PROJECT NAME: EAST MONTPELIER	PLOT DATE: 2/17/2017
PROJECT NUMBER: BRF 037-1(7)	DRAWN BY: E. ALLING
FILE NAME: ...18_Drainage plans.dgn	DESIGNED BY: K. RICHARDSON
PROJECT LEADER: T. KNIGHT	CHECKED BY: G. GOYETTE
DRAINAGE PLANS-DP 1	SHEET 31 OF 158

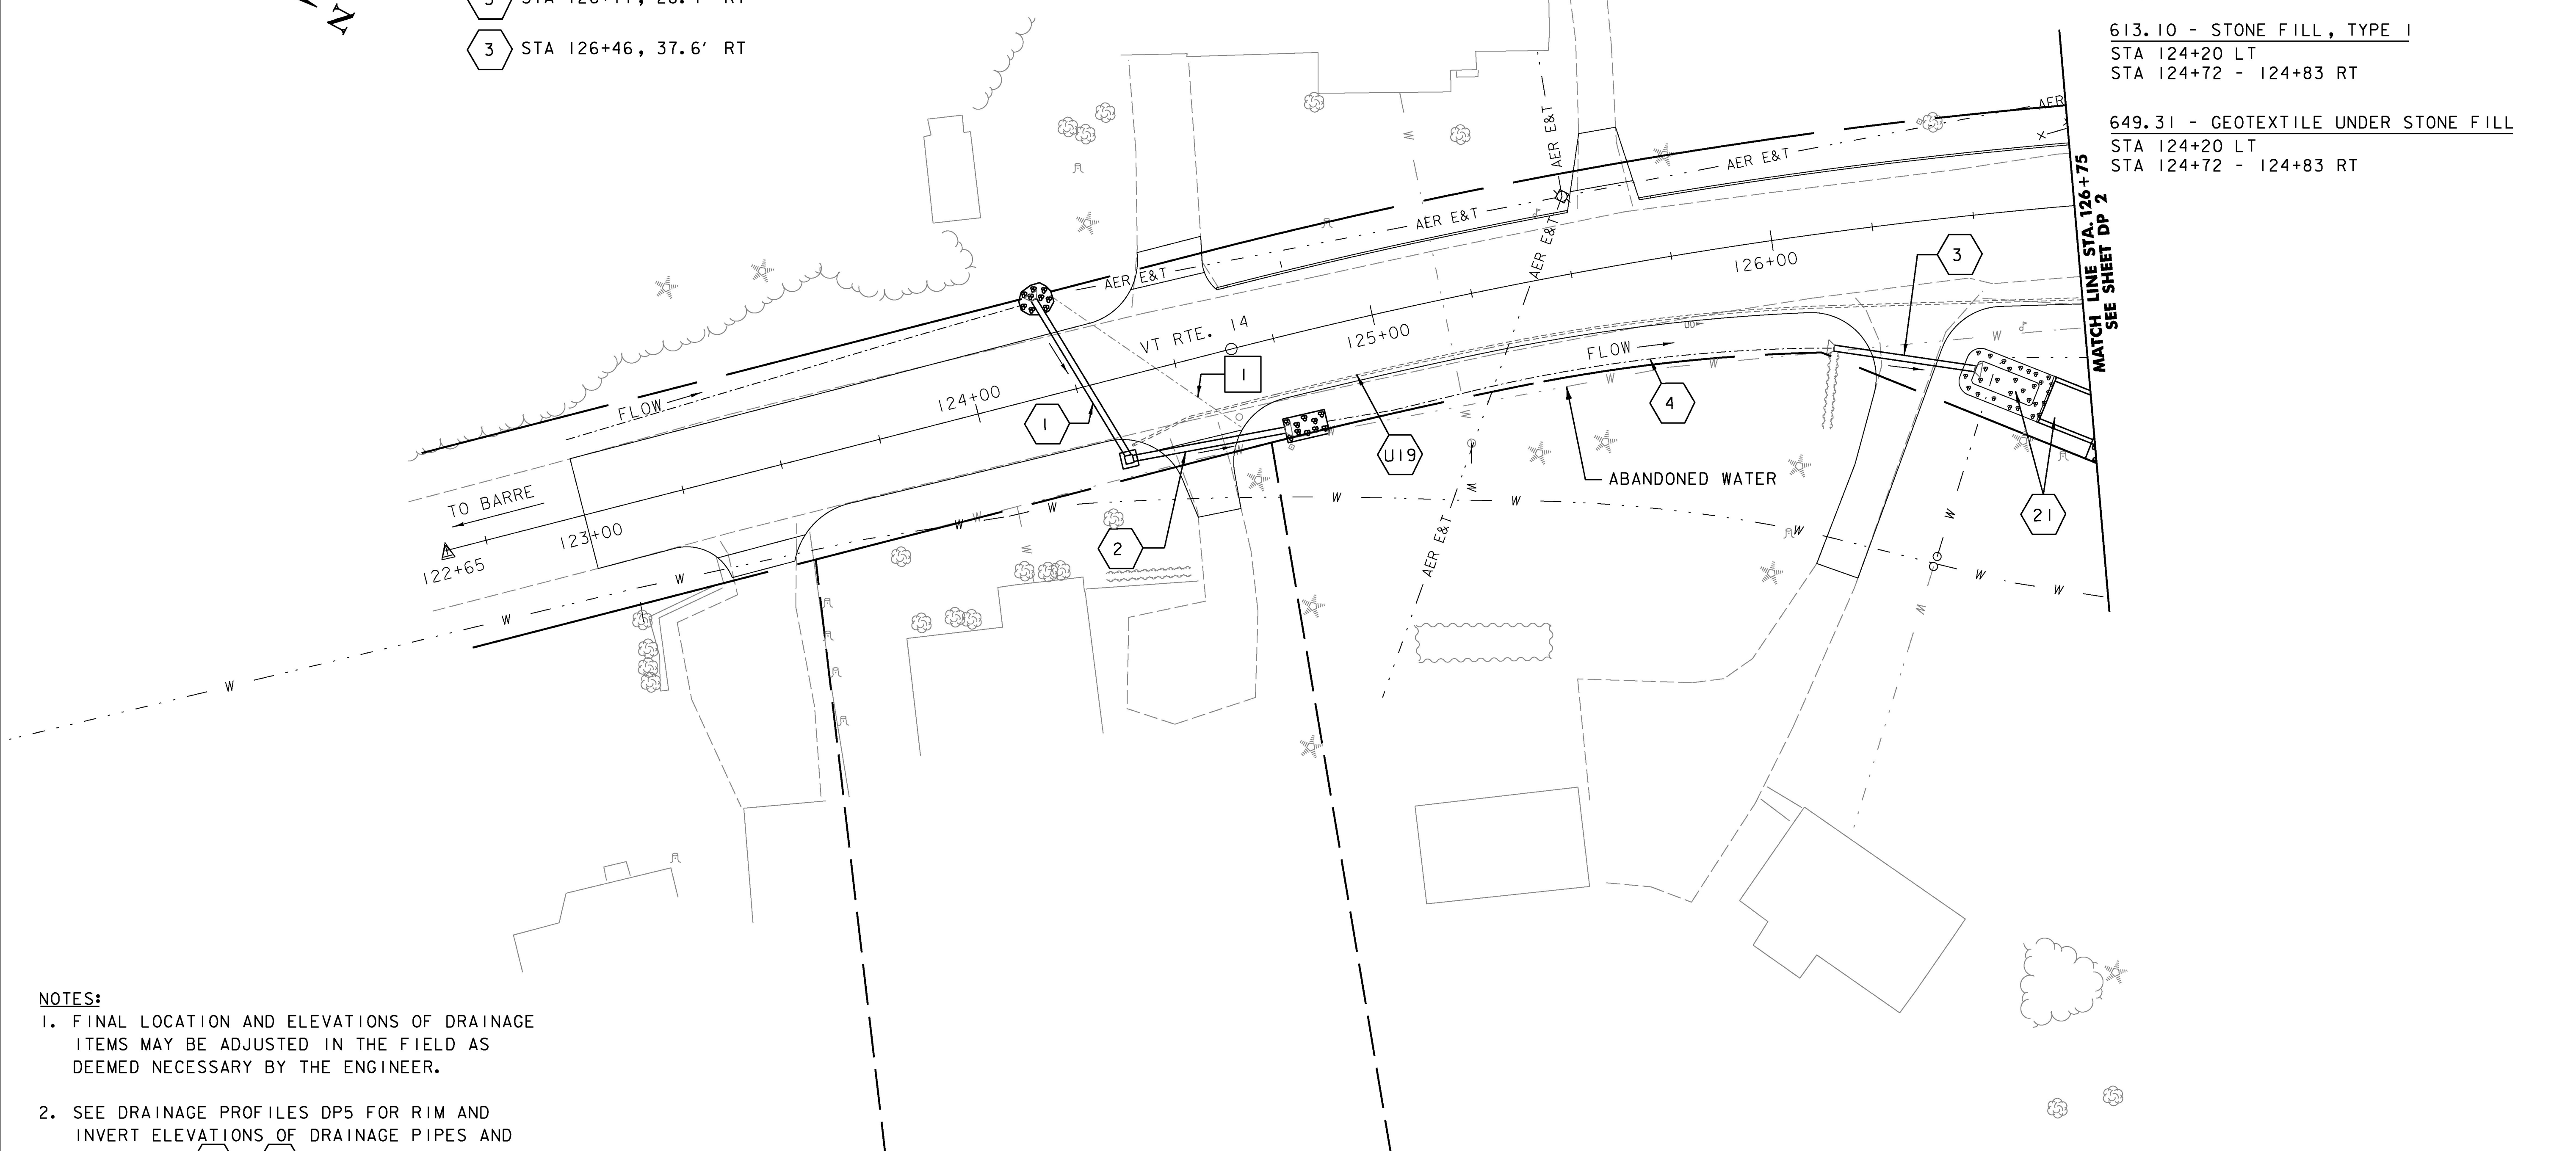
- U19 STA ~~124+35 RT~~ - 126+75 RT
124+89
